7/21/21	<span style="color:red">6</span> Added Removal of Existing Delineators
7/14/21	<span style="color:red">4</span> Added Clear & Grub Limits
DATE	REVISION
STATE OF HAWAII DEPARTMENT OF TRANSPORTATION HIGHWAYS DIVISION	
<b>DEMOLITION AND EROSION CONTROL</b>	
<b>INTERSTATE ROUTE H-1 RESURFACING</b>	
Miller Pedestrian Overpass to Kapiolani Interchange	
Federal-Aid Project No. NH-HI-1(279)	
Scale: 1" = 40'	
Date: August 2021	
SHEET No. EC4 OF 23 SHEETS

<b>DEMOLITION AND EROSION CONTROL</b>	
INTERSTATE ROUTE H-1 RESURFACING	
Miller Pedestrian Overpass to Kapiolani Interchange	
Federal-Aid Project No. NH-HI-1(279)	
Scale: 1" = 40'	
Date: August 2021	
SIGNATURE	04/30/22
EXPIRATION DATE OF THE LICENSE	
SHEET No. EC7 OF 23 SHEETS

DEMOLITION AND EROSION CONTROL	
<u>INTERSTATE ROUTE H-1 RESURFACING</u>	
<u>Miller Pedestrian Overpass to Kapiolani Interchange</u>	
Federal-Aid Project No. NH-HI-1(279)	Date: August 2021
Scale: 1" = 40'	
SHEET No. EC8 OF 23 SHEETS

SHEET NO. R15 OF 41 SHEETS

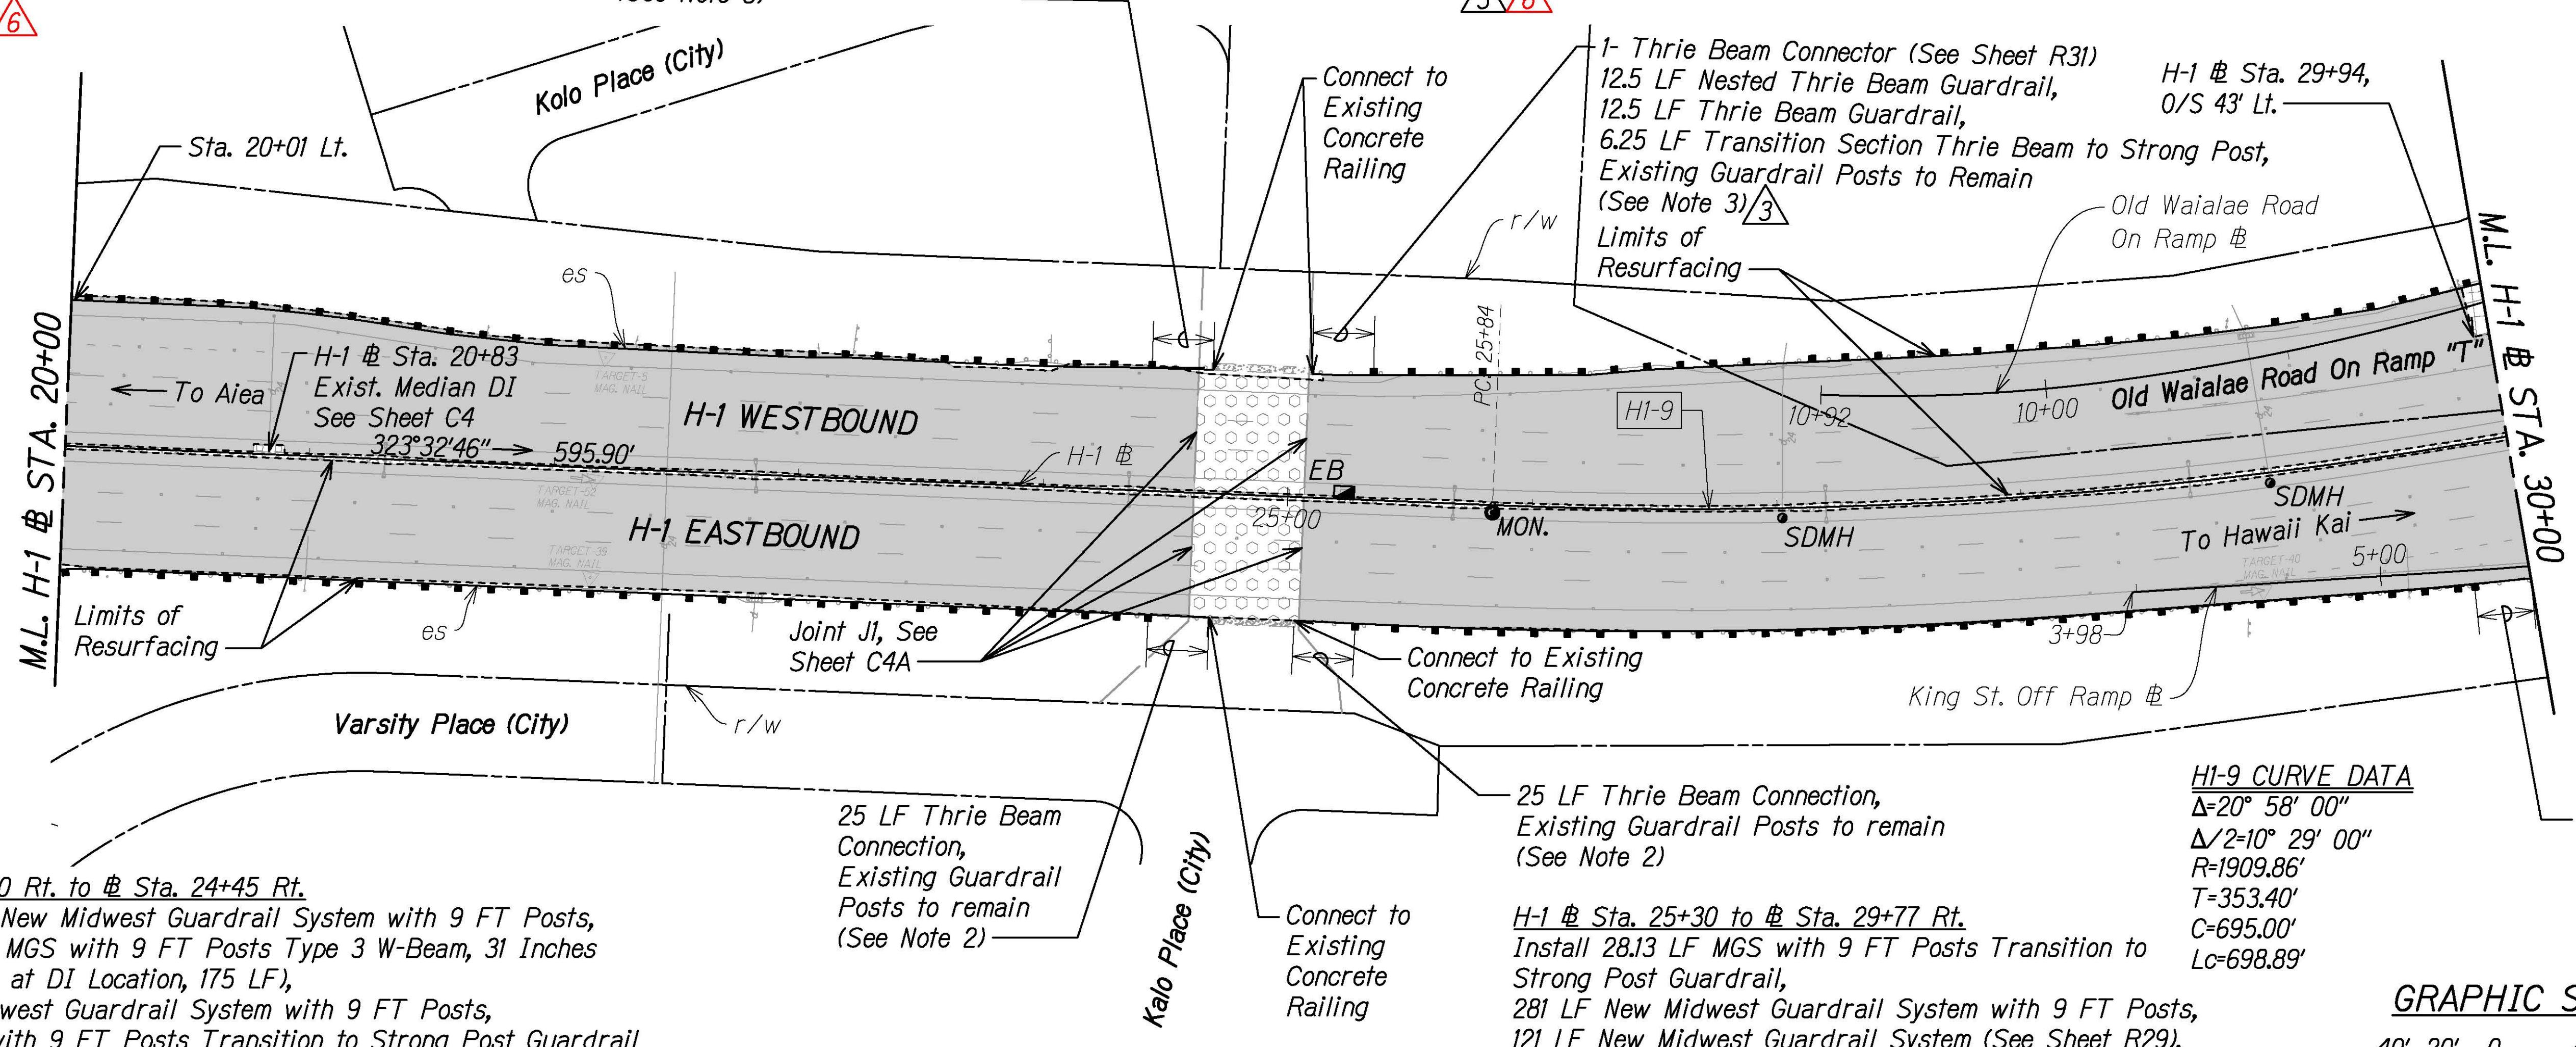
H-1 # Sta. 25+39 to Waialae On Ramp # Ah. Sta. 7+50 Lt.

Install 28.13 LF MGS with 9 FT Posts Transition to Strong Post Guardrail,

45 LF New Midwest Guardrail System with 9 FT Posts,

New Long-Span MGS with 9 FT Posts Type 3 W-Beam, 31 Inches

(3-Post Omitted at Inlet Location, 175 LF),

7/21/21	<b>6</b> Revised Guardrails
7/9/21	<b>3</b> Revised Guardrails, Pav't Section & Limits, Added Exist. Median DI Label
DATE	REVISION

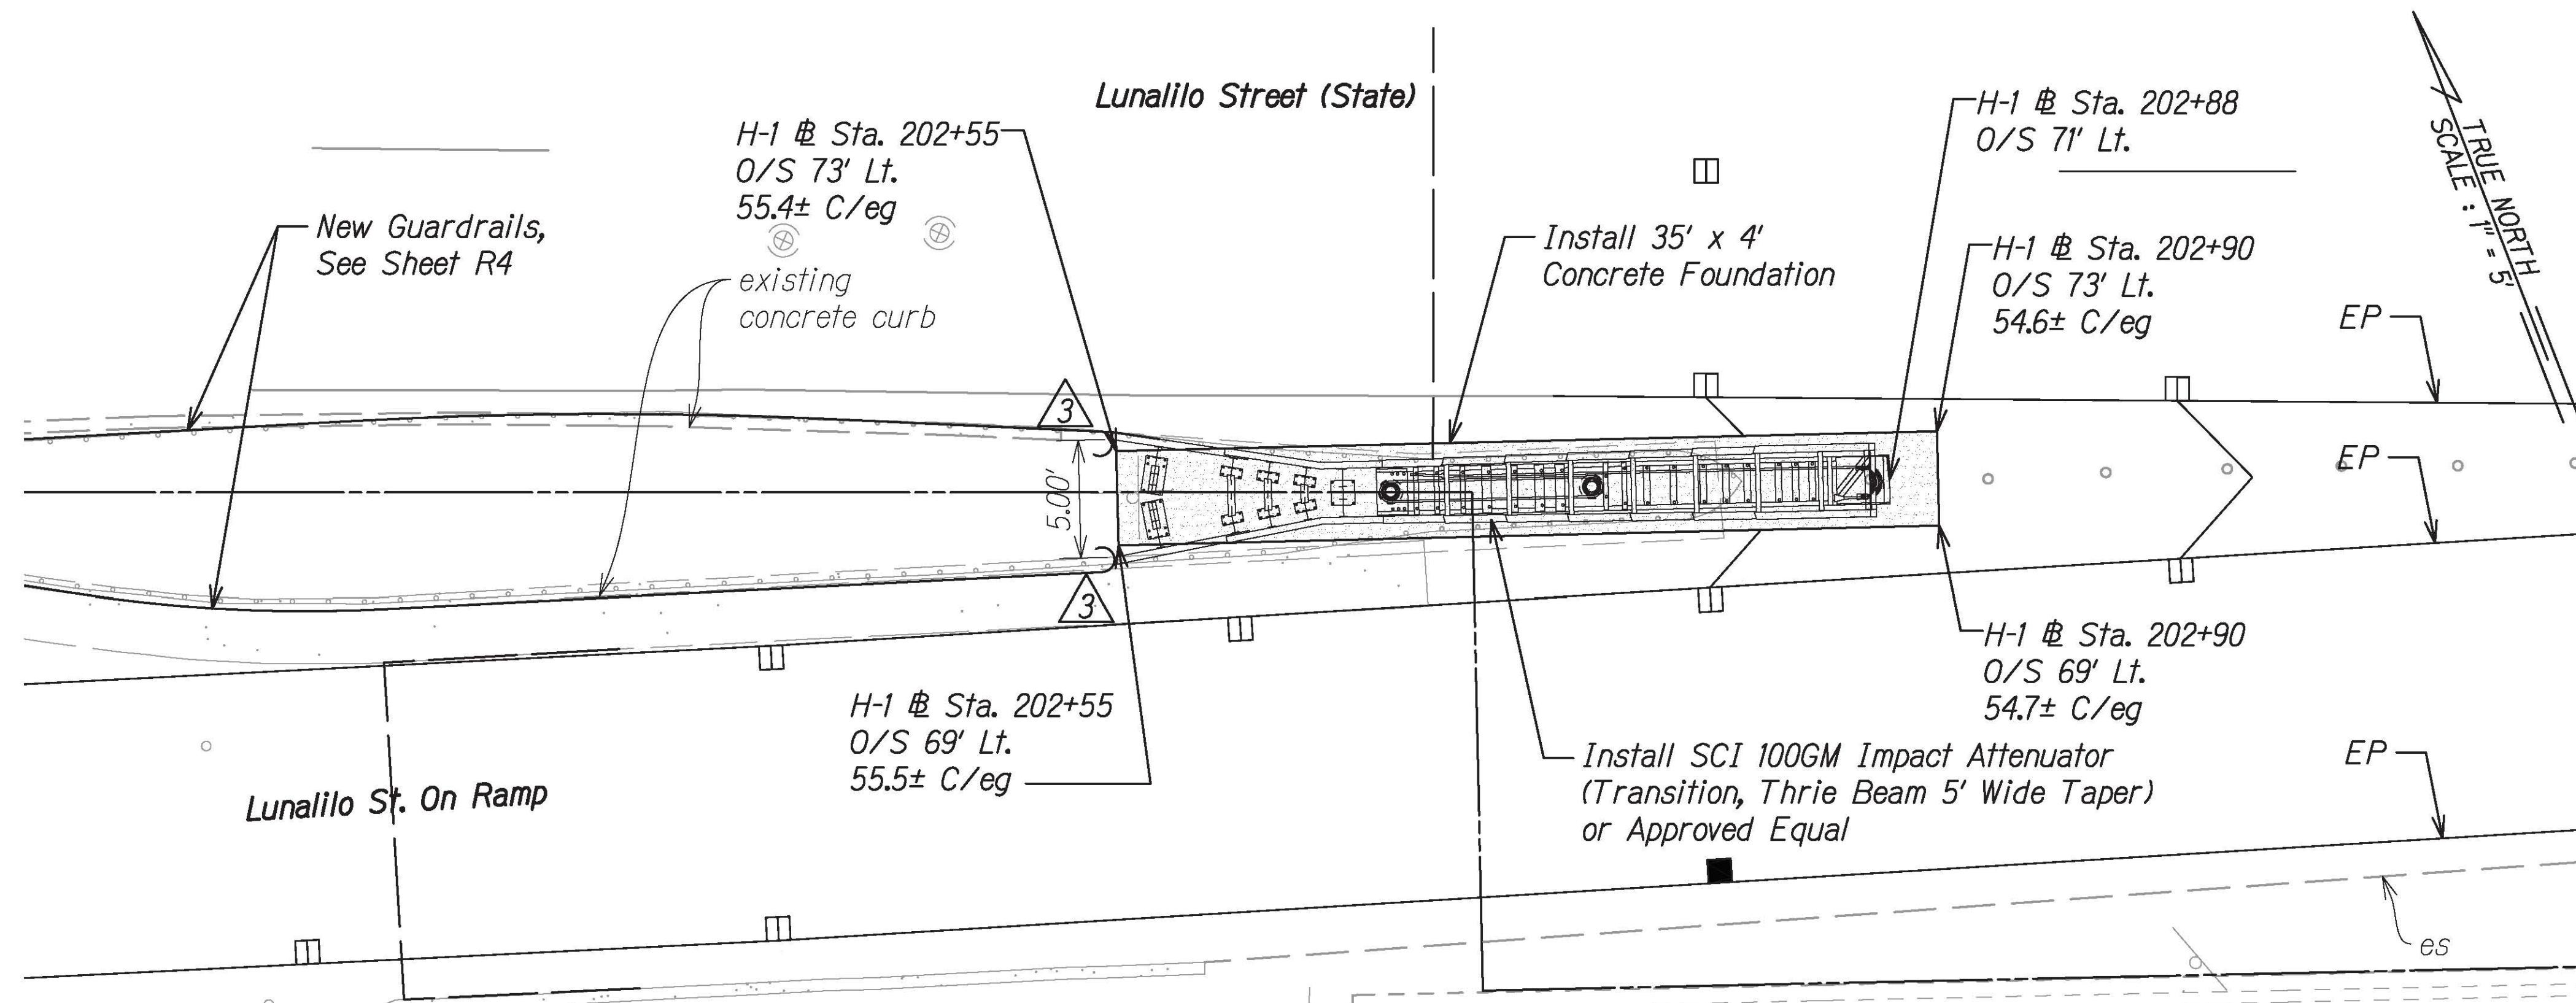
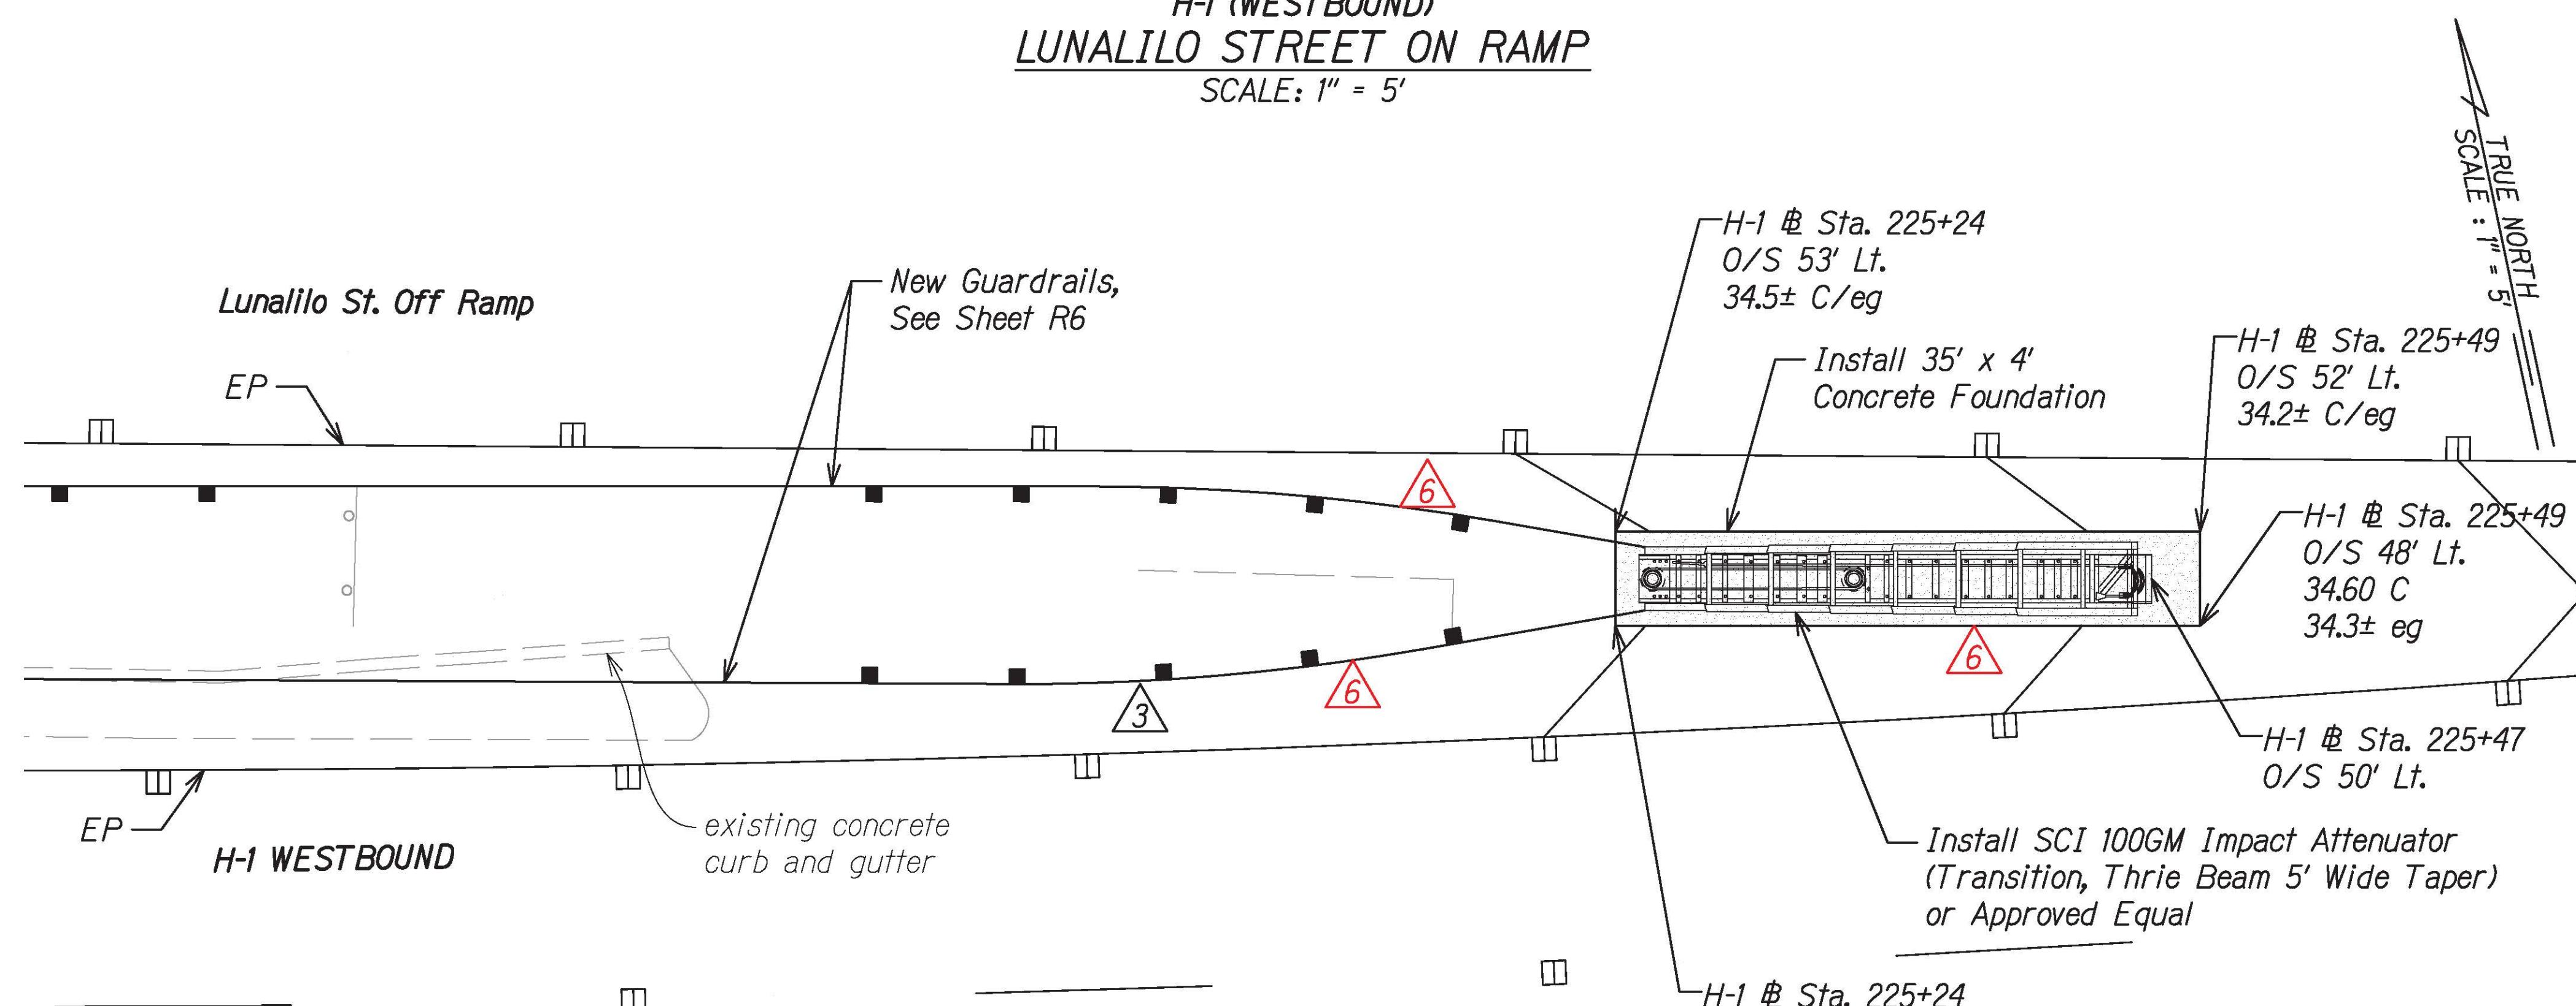
7/21/21	Revised Guardrail and Moved Attenuator
7/9/21	Revised Guardrails
DATE	REVISION
STATE OF HAWAII DEPARTMENT OF TRANSPORTATION HIGHWAYS DIVISION	
<b>IMPACT ATTENUATOR DETAILS</b>	
INTERSTATE ROUTE H-1 RESURFACING Miller Pedestrian Overpass to Kapiolani Interchange Federal-Aid Project No. NH-HI-1(279)	
Scale: 1" = 5' Date: August 2021	
SHEET No. R38 OF 41 SHEETS
